SUBJECT: RESULTS OF DAM SAFETY AUDIT RELATED TO THE CATEGORY I  
AUXILIARY RESERVOIR DAM AT THE SHEARON HARRIS NUCLEAR  
POWER PLANT

OPERATION INSPECTION REPORT  
for  
THE NUCLEAR REGULATORY COMMISSION

Dam (name) Auxiliary Reservoir Dam

NRC Licensed Project Shearon Harris Nuclear Station

**Photograph 3**

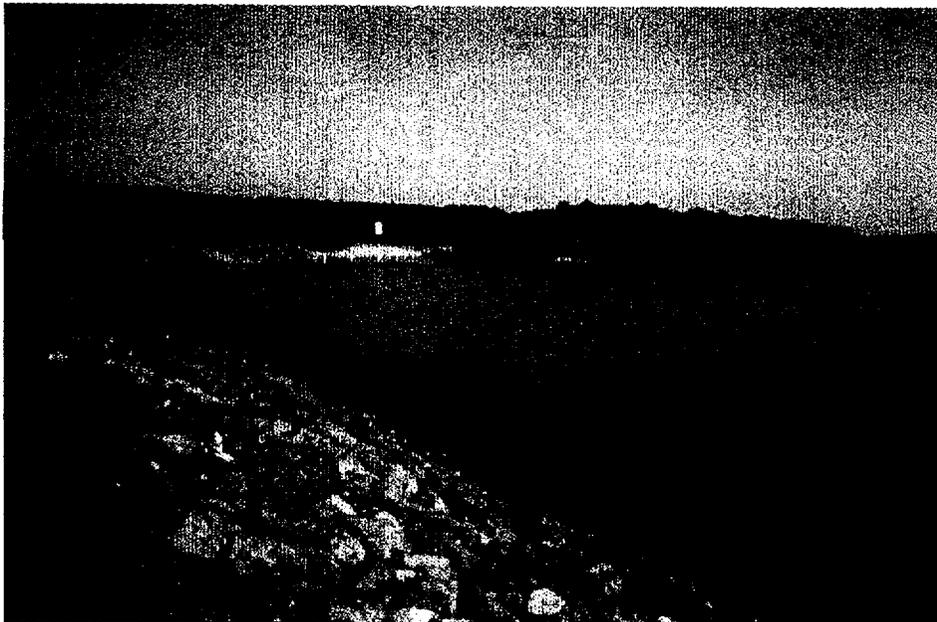
**a. Auxiliary Reservoir Dam.** Both upstream and downstream slopes of the dam are protected by riprap (Photographs 2 and 4). No sign of movement such as sliding, sloughing, or subsidence was detected on either of the slopes. The crest and gravel roadway along the top of the dam also appeared to be in good condition (Photograph 3). There was no sign of cracking, sliding, or settlement along the crest.

2. **Instrumentation.** Project instrumentation includes surface monuments and piezometers. Surface monuments located along the crest of the dam are used to monitor horizontal and vertical movement. Piezometers are located along the crest of the dam and downstream of the toe. Photograph 3 shows a typical location of a survey reference point and/or piezometer with protective barriers.

Barricades on top of the dam. The barricades protect monuments and piezometers.

**Photograph 4**

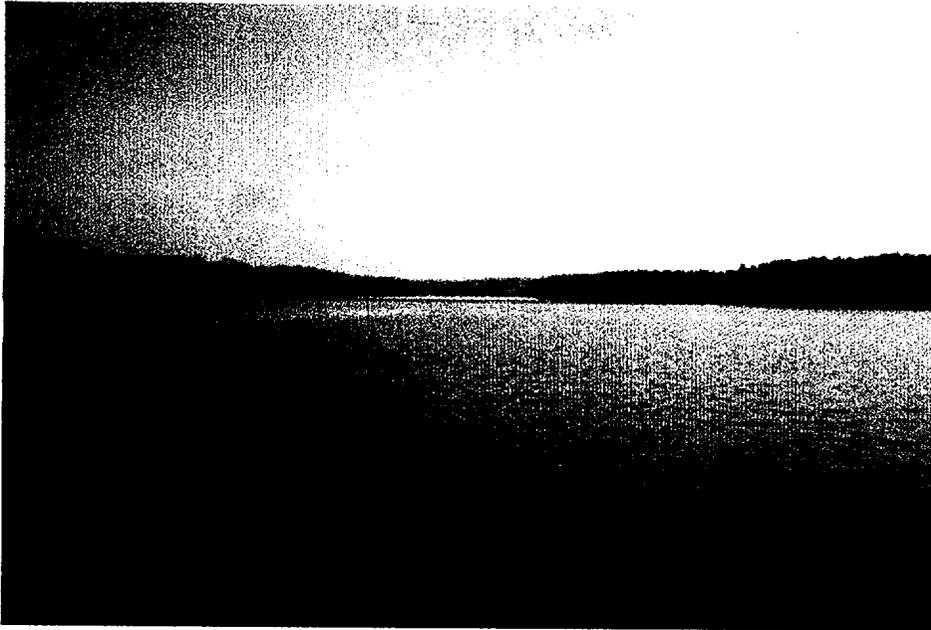
View of the upstream side of the dam looking toward the spillway and right abutment.

**Photograph 10**

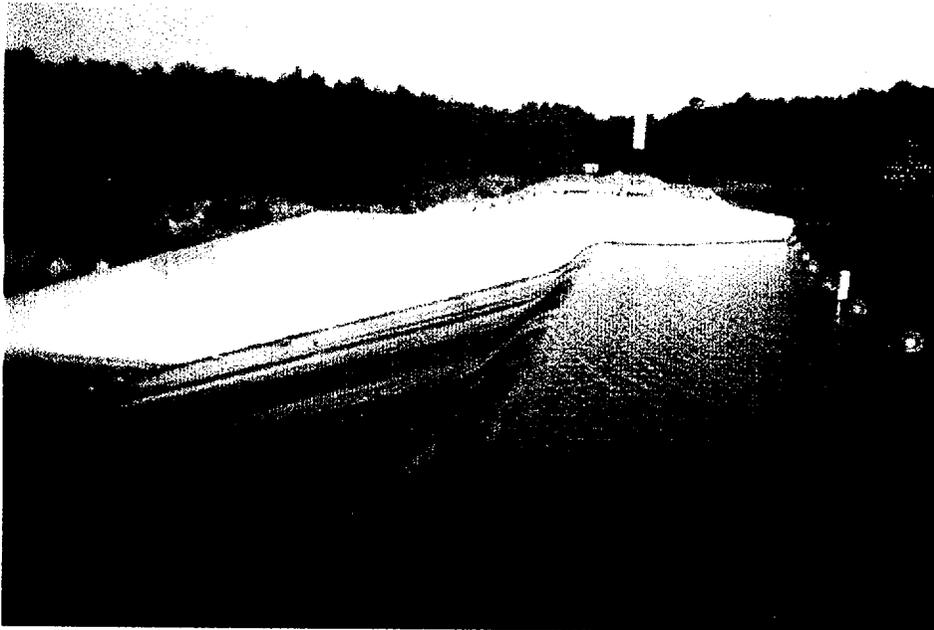
**b. Spillway.** The spillway is an uncontrolled, ungated, overflow type structure (Photographs 10 to 13). The reinforced concrete structure is located near the right (west) abutment of the dam. The reinforced concrete training walls extend from within the reservoir, across the dam, and along the downstream slope into the outlet channel (Photograph 12). Overflow from the auxiliary reservoir passes over the spillway crest, along an outlet channel and into the main reservoir (Harris Reservoir). A boat barrier is located upstream of the spillway

Embankment, left spillway training wall, and spillway channel.
